Subject:
CPT/UVOST Field Investigation Report Addendum
Former BP Station No. 11109
4280 Foothill Boulevard
Oakland, California

This *CPT/UVOST Field Investigation Report Addendum* has been prepared in response to a meeting between Alameda County Environmental Health (ACEH) and Arcadis U.S., Inc. (Arcadis) on December 10, 2015 which discussed the current status of the Former BP Service Station No. 11109 located at 4280 Foothill Boulevard in Oakland, Alameda County, California (the Site; Figure 1). The meeting was precipitated by the sample results and findings presented in the *CPT/UVOST Field Investigation Report* dated September 16, 2015 (Arcadis 2015).

Below are responses to the ACEH comments from the March 1, 2016 email, ACEH comments are in bold with responses following.

CPT Log for B-7

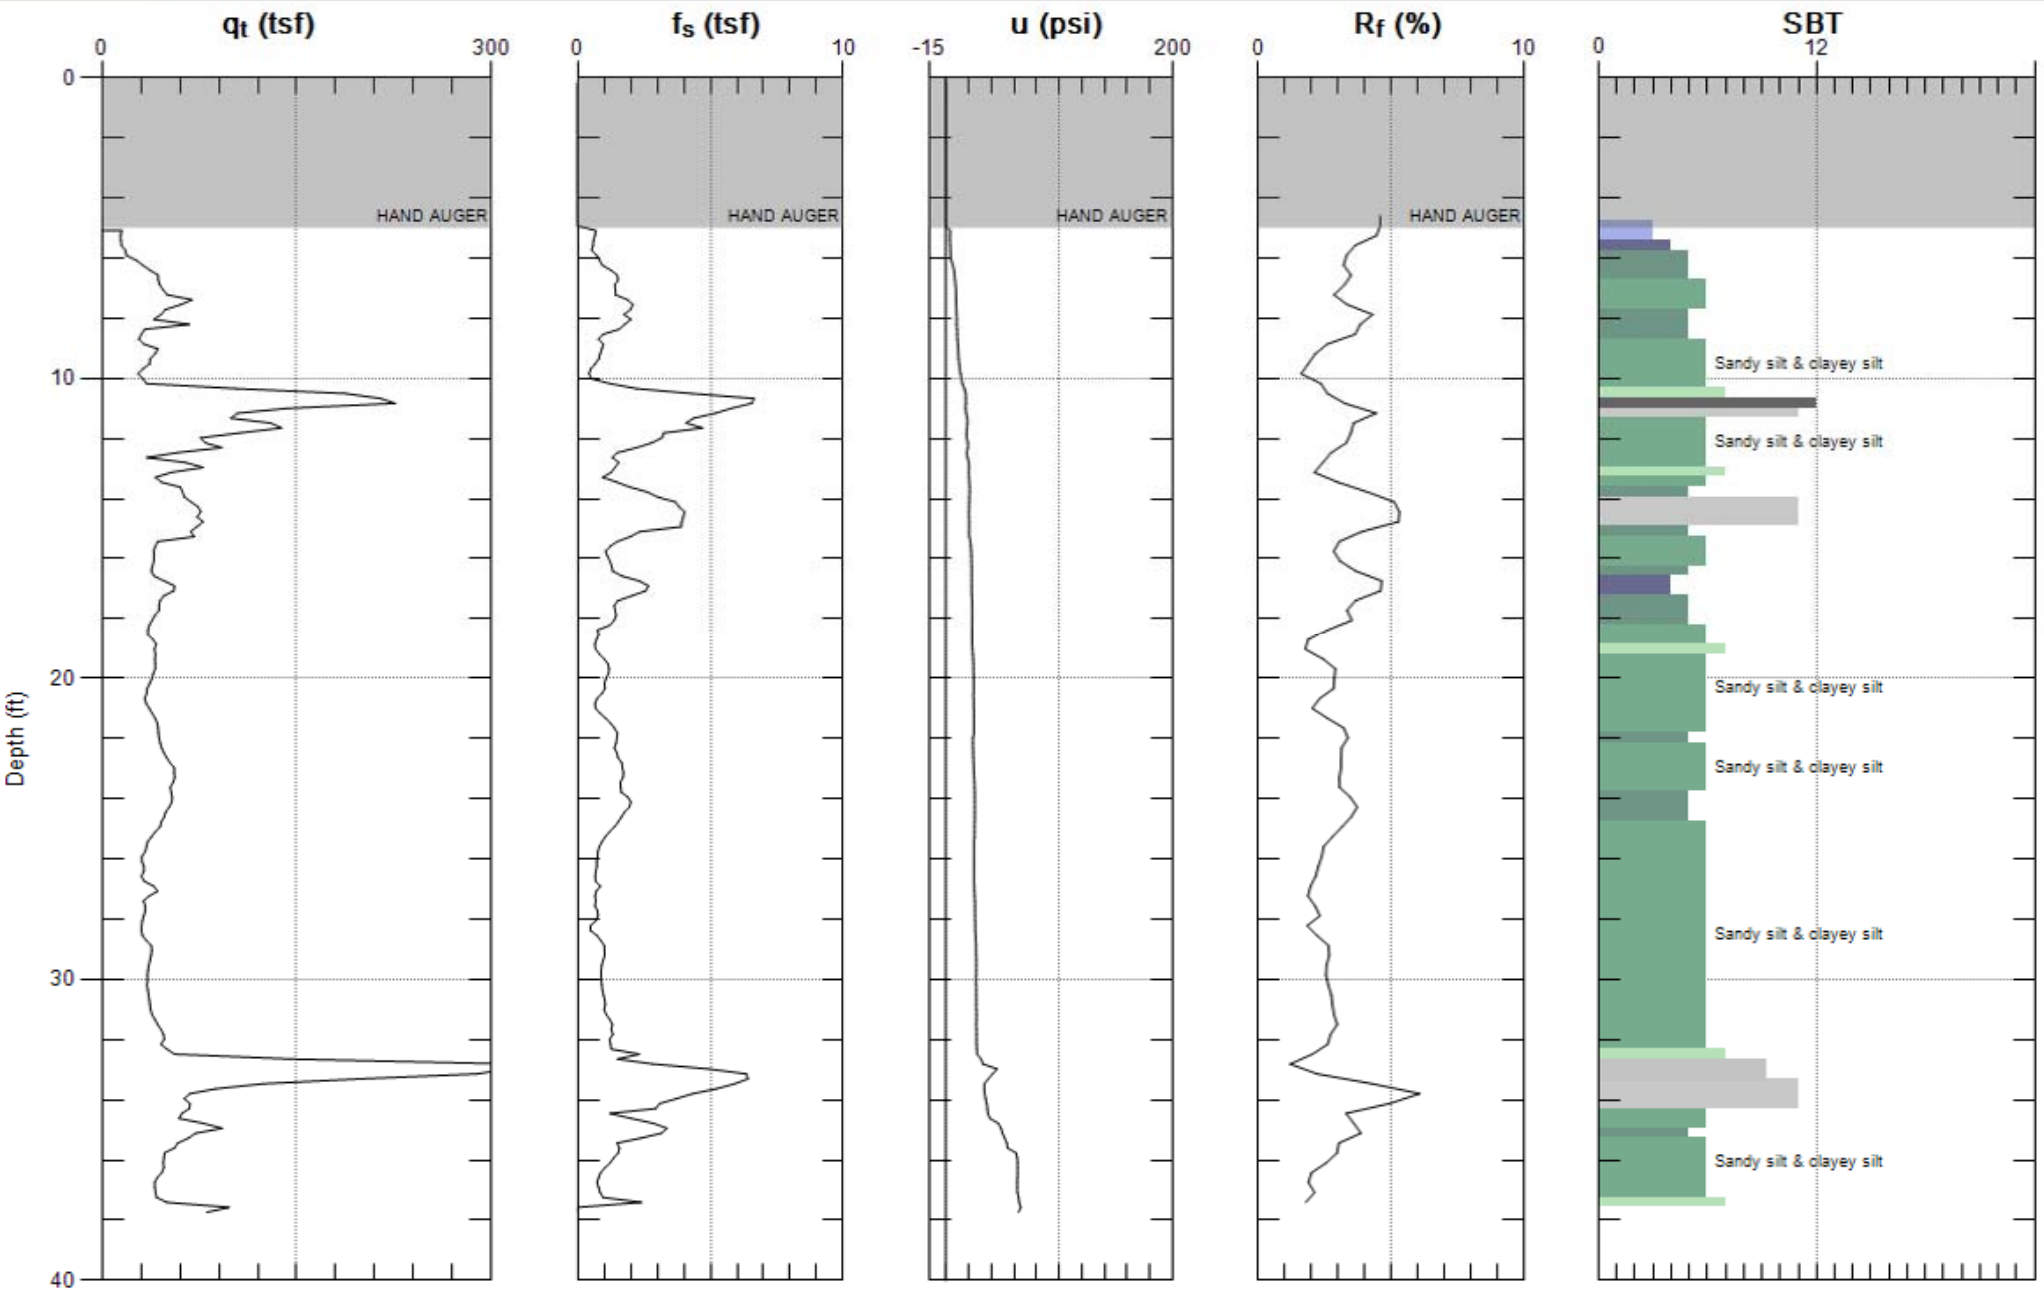
- i. **Soil boring logs were provided for B-3, B-4, B-5 and B-8, CPT/UVOST logs were provided for B-1, B-3, B-4, B-5, and B-6, and page one of two was provided for B-7. Please provide soil boring logs for B-1, B-6, and B-7 and the second CPT/UVOST log page for B-7. Also, please provide a legend/key for the CPT/UVOST logs;**
- ii. **Please revise the boring logs and CPT/UVOST logs and add the depth of first encountered groundwater and the screen interval for the grab groundwater collection;**
- iii. **Please describe why grab groundwater samples were collected at the chosen depths in the borings.**

The CPT log of B-7 and a key reference for the CPT/UVOST borings logs are included as Attachments 1 and 2, respectively.

At B-7, the CPT log did not indicate the presence of any significant permeable zones. As groundwater is typically observed at depths shallower than 15 feet btoc in groundwater monitoring wells located in this offsite area, it appeared warranted to set the screened interval at such a corresponding depth. Furthermore, an approximate 1.5 foot thick unit identified as *very stiff, fine grained over consolidated* was encountered at 14 feet bgs. The presence of this very stiff, fine grained unit suggested that a water

bearing zone was not likely to be encountered at a deeper depth within the boring. As such, setting the screen for groundwater sampling from 9 – 14 feet bgs appeared to be appropriate for B-7.
